PARRAMATTA BIKE PLAN

VOLUME 4: PUBLIC CONSULTATION REPORT

Draft Bike Plan 2017 - 2037

Public Consultation Report

Figure 3 Top Ten Support for Like Spots

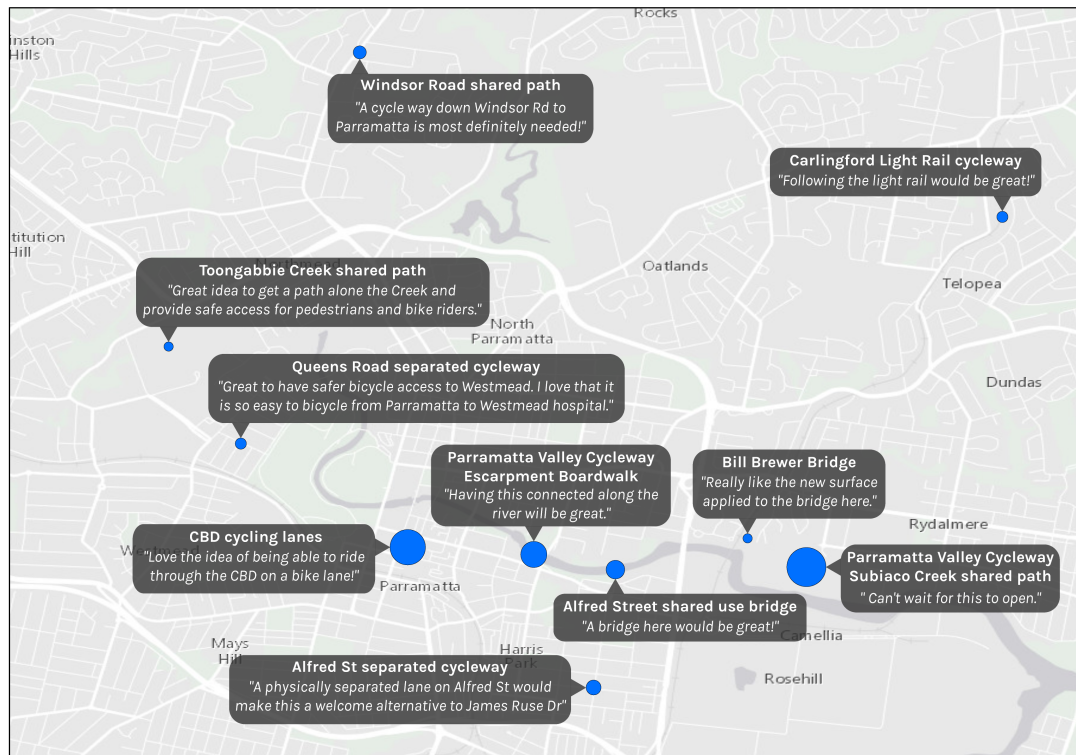
The spots receiving the most 'supports' included the completion of the Subiaco Creek path (21 supports), CBD cycling lanes (19 supports), and the Escarpment Boardwalk along the northern bank of the Parramatta River (14 supports). A future bridge at Alfred Street over the Parramatta River was also popular (10 supports), and also the Alfred Street separated cycleway through Harris Park (8 supports).

Figure 4 Top Ten supports for Issue Spots

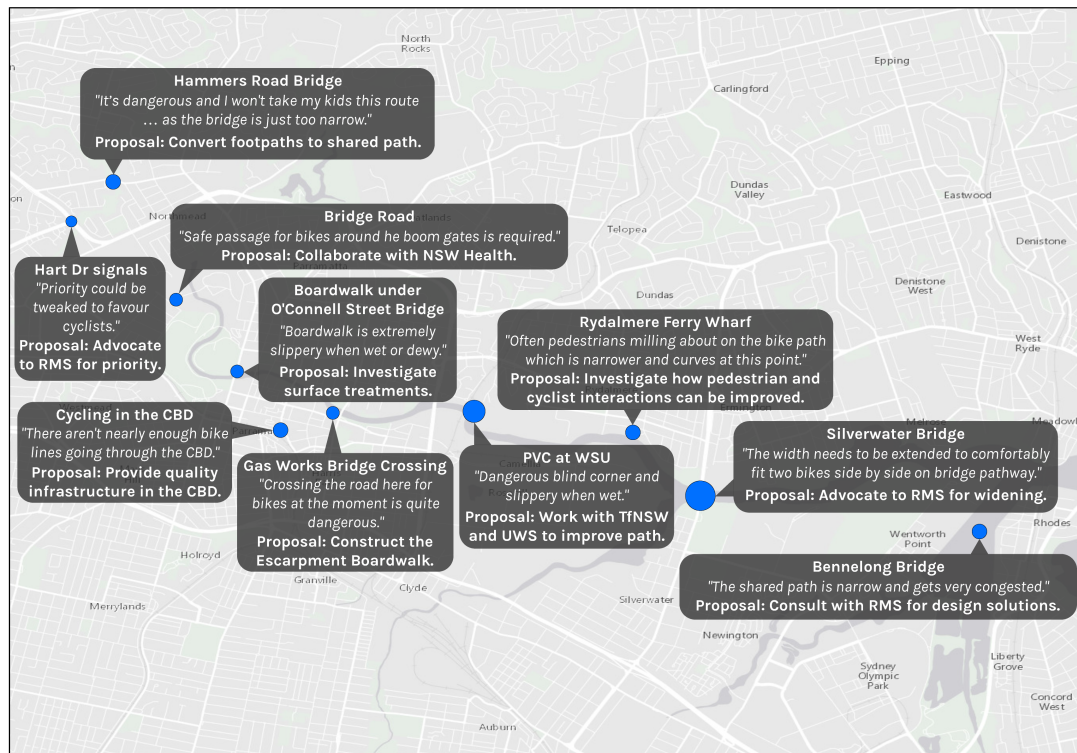
Figure 4 provides an illustration of the top ten issue spots in terms of the number of *supports* the contribution received. As with the like spots, the method used to determine the number of supports was to include the original contributor, in addition to those who clicked the support button, as well as any comments that were assessed as being ostensibly supportive of the original contribution. The narrow crossing on both sides of the Silverwater Bridge received the highest number of supports (16).

A location of the shared path that runs as part of the PVC near the south east corner of Western Sydney University (WSU) was identified by a large number of CrowdSpot contributors for its sharp corner and surface quality issues. The corner itself cannot be eliminated but a safer surface can be investigated. It will however be incumbent upon people to ride within their ability, and minimise risk, to themselves and other path users. This is an area under the control of WSU and City Trains, and Council will need to work with these agencies to seek solutions to the issues raised by the community in this location.

Similarly, the path along the Parramatta River under the O'Connell Street bridge was identified as having a hazardous surface (wooden). Whilst it is unlikely the corner itself can be eliminated or even reduced, it will be possible to install a safer surface, though riders will need to ensure they ride within their abilities, the conditions and path geometry. A similar situation was reported by a number of CrowdSpot contributors at the section of path that runs under Marsden Street.

A particular section on the Bennelong Parkway was also a focal point for members of the public who identified that they felt very unsafe when crossing this point to connect to the shared path along the wetlands around Homebush Bay. People commented that this was particularly concerning crossing with children and families. The initial contributor noted: *'It would be made much safer if there was pedestrian crossing or traffic lights with a pedestrian button'* – female, 35 – 49 years old.

Figure 13 - Resolved Spots

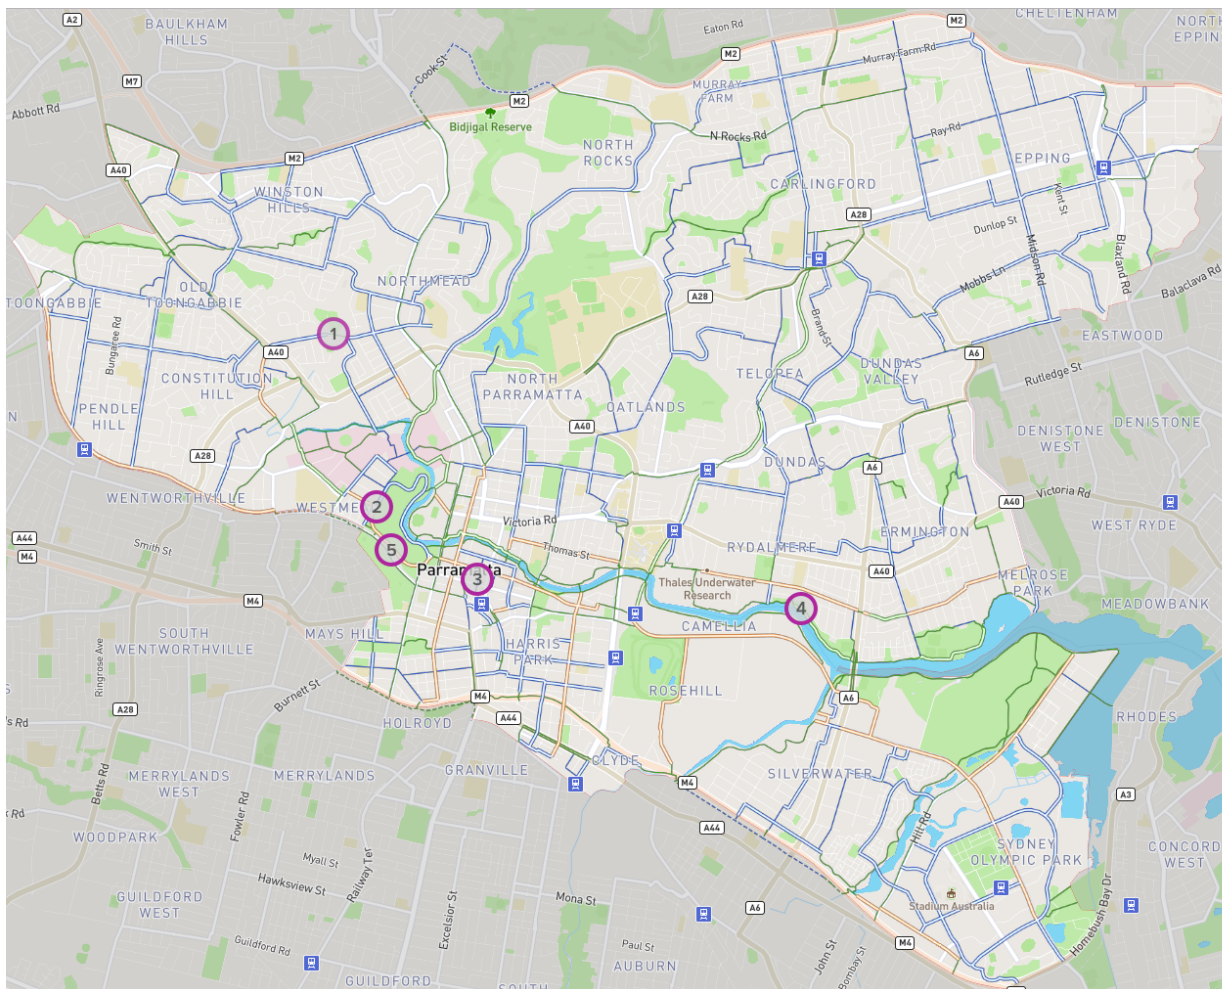
These are high priority locations identified by the public as 'issues' that have already been addressed on the ground or in the proposed Draft Bike Plan.

1. Narrow concern on Hammers Rd Bridge - Each footpath to be made a shared path so cyclists do not have to ride on the bridge roadway.
2. Improving entrance to Parramatta Park from Queens Road - Queens Rd Cycleway (in construction) will bring a wider, 24-hour access curb ramp at the existing entrance.
3. Connection to Parramatta Square and WSU - Current draft plans for a shared path connection to the University Campus as an interim measure until the Civic Link is realised.
4. Rydalmere Ferry Wharf - Bike path intersects with ferry pedestrian access. Council allocated \$1.25M to separate pedestrians and cyclists through Eric Primrose Reserve.
5. Parramatta Park Two-way Bike Lanes - The proposed southern link is proposed to be both directions.

Figure 14 – Advocacy Spots

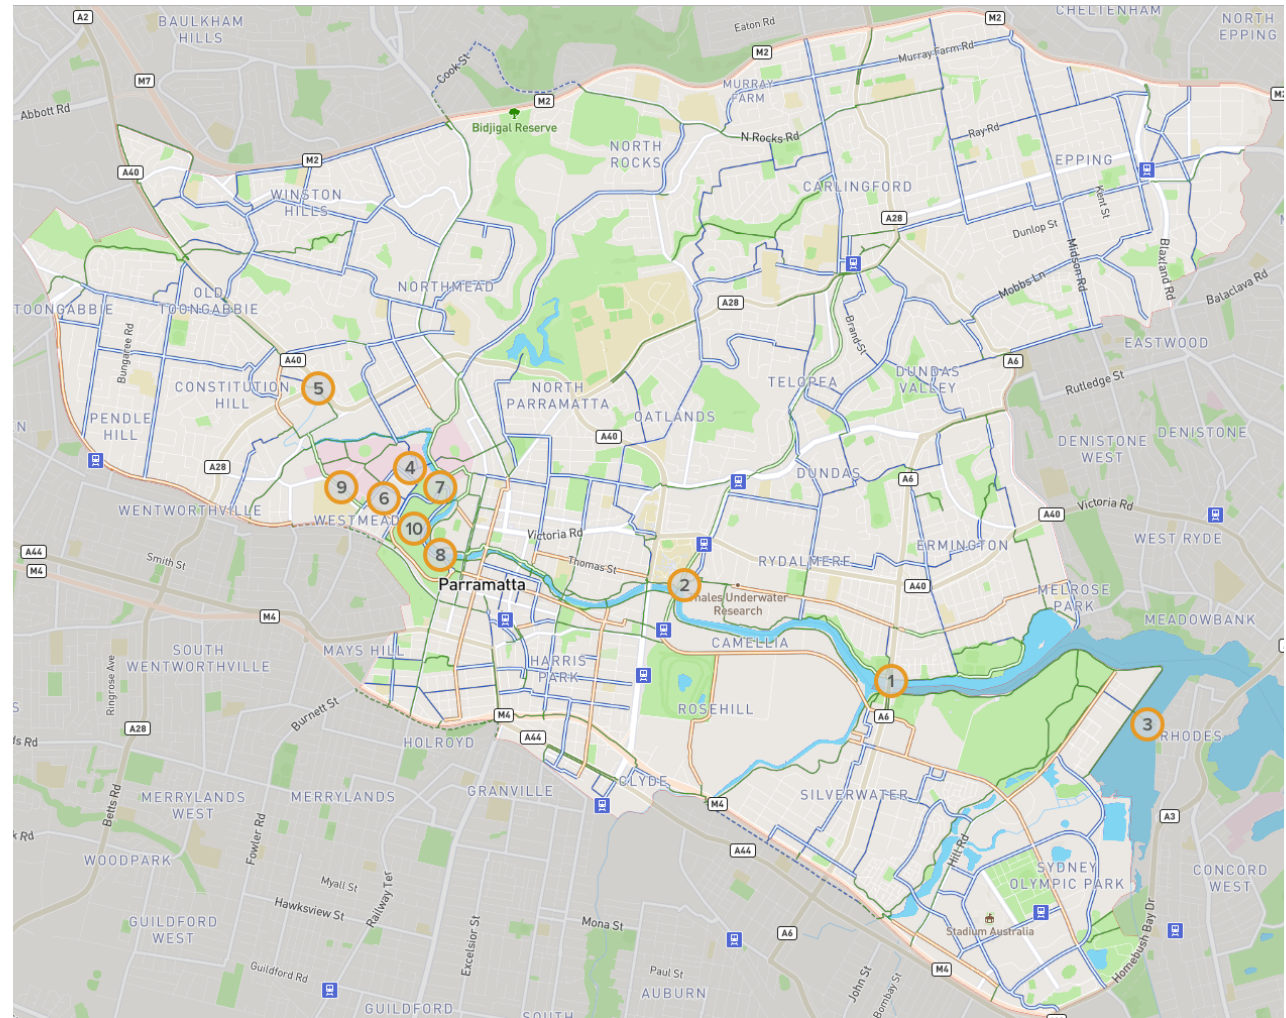
1. Silverwater Bridge (narrow) – RMS
2. Parramatta Valley Cycleway near UWS (poor surface) – UWS/City Trains
3. Bennelong Bridge (narrow) – RMS
4. Bridge Rd, Westmead (safe boom gate passage) – NSW Health
5. Traffic light crossing Hart Dr at Old Windsor Rd - RMS
6. Parramatta Park river connection – NSW Health
7. Bridge access to Parramatta Park – Parramatta Park
8. Westmead Oral Health Entrance – RMS
9. New hospital access road at Mons Rd Cuts through existing bicycle path - NSW Health
10. Seal gravel cycleway path behind Parramatta Stadium – Parramatta Park

Figure 15 – Maintenance Spots

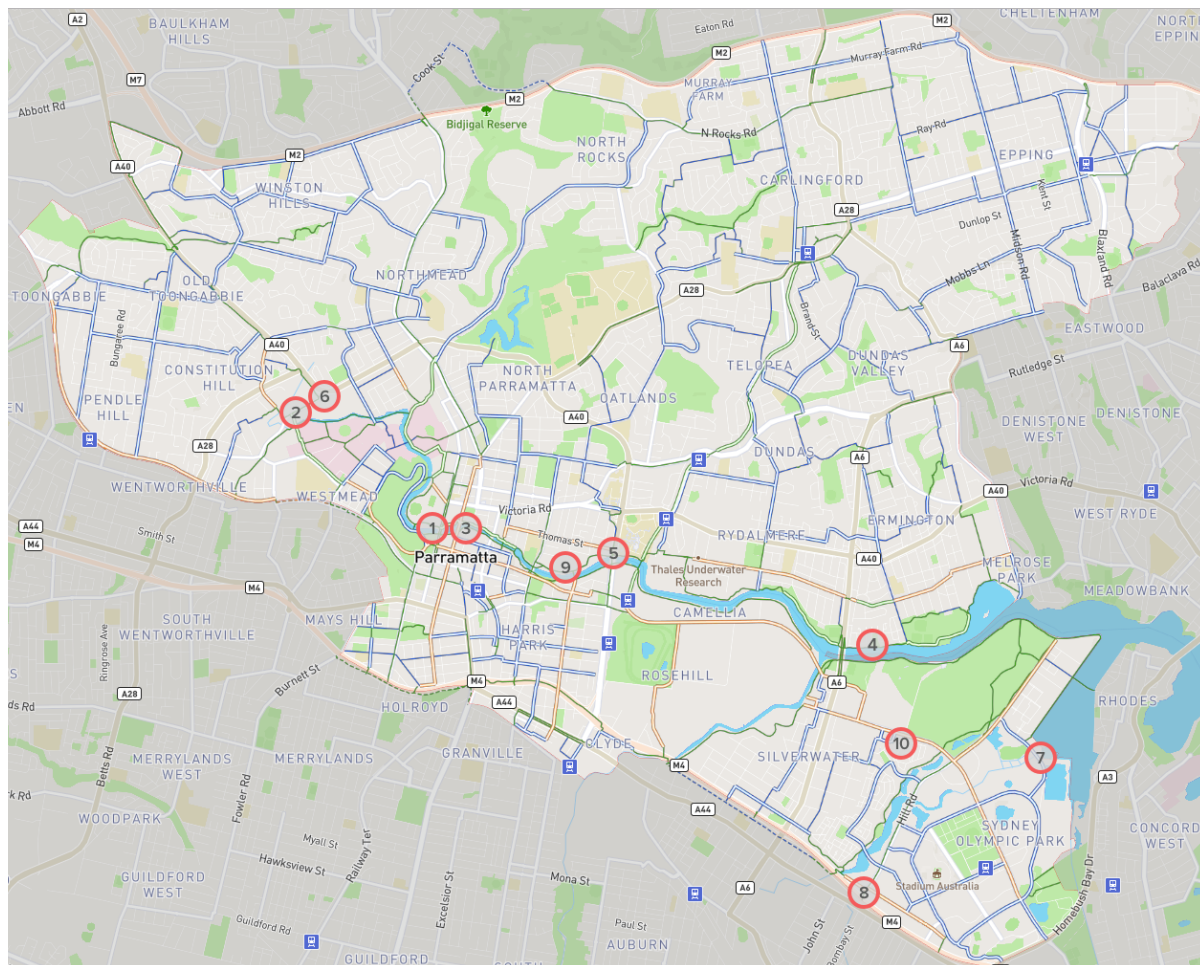
1. Parramatta Valley Cycleway Boardwalk near O'Connell St – Slippery when wet
2. Shared Path along Briens Rd – Vehicle driveway issues
3. Path under Marsden St – Blind corner
4. Parramatta Valley Cycleway - Water does not drain from path
5. Cycleway Intersection under James Ruse Drive – Dangerous section due to gradient and riders in opposing directions.
6. T-Way bike path Briens Rd – Pole in middle of path at blind corner
7. Bennelong Parkway – Difficult crossing
8. M4 exit crossing – Vehicles not stopping for pedestrians or riders.
9. Parramatta Valley Cycleway - Direct users to stay on the Cycleway rather than sending them up to Morton Street.
10. Newington Library – More bicycle parking
